DSAX95004Q-01

S E R V I C E N O T E

DSAX95004Q Infiniium High-Performance Oscilloscope: 50 GHz

Example of the data flyers:

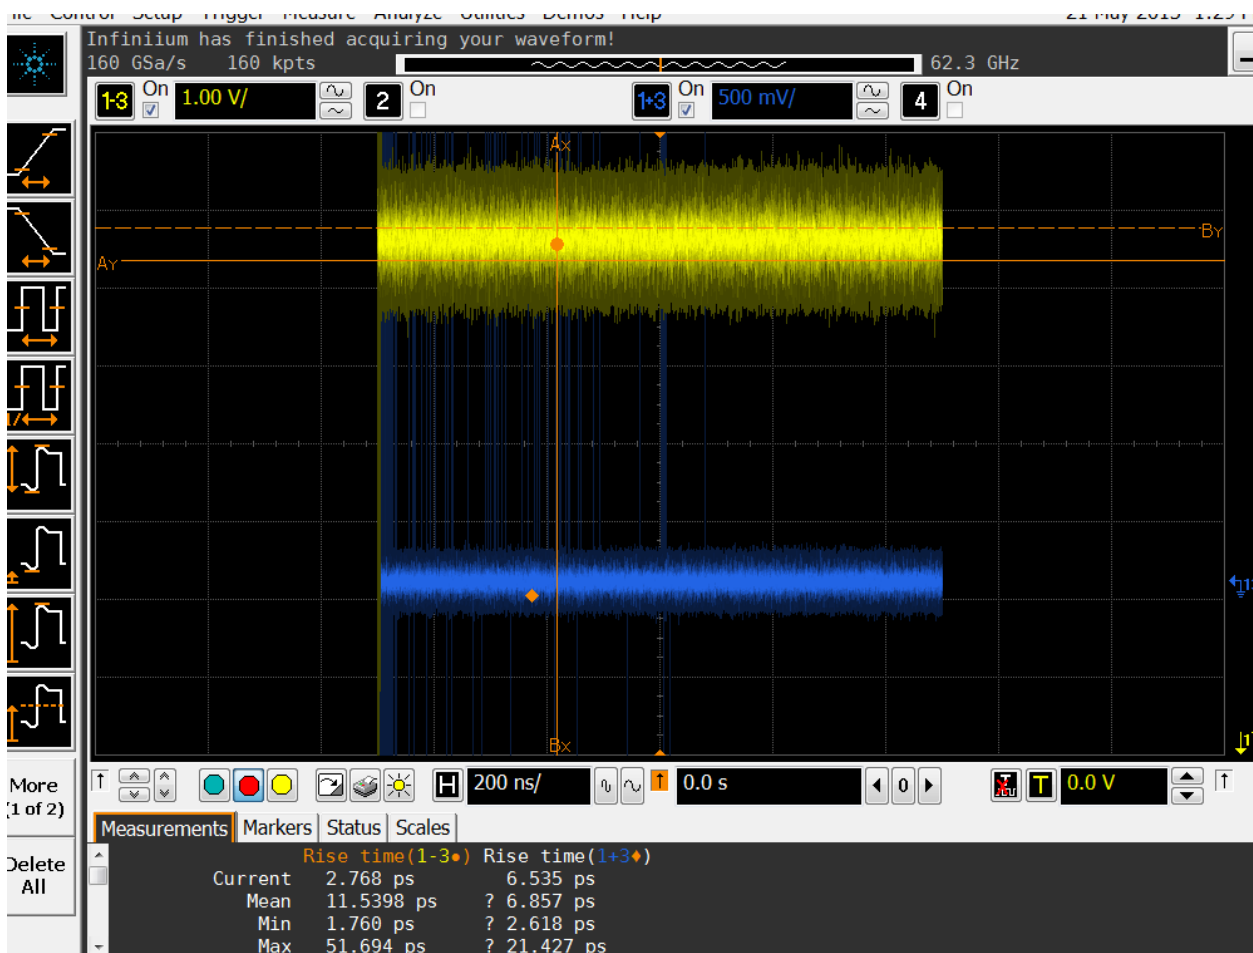
Using the Real Channels with differential mode on and or Precision Probe on, causes the Main FPGA to dip and data fryers are observed due to voltage variations.

Starting in July 2013 week 33 and ECO was implemented changing the power supplied to the Main FPGA. This fixed the Real channels having Data Flyers due to voltage variations. Scopes shipped previous to this ECO need to be updated to the reworded Backplane assembly.

Replace Backplane assembly following the service manual procedure. Factory Calibration is required after the backplane replacement.
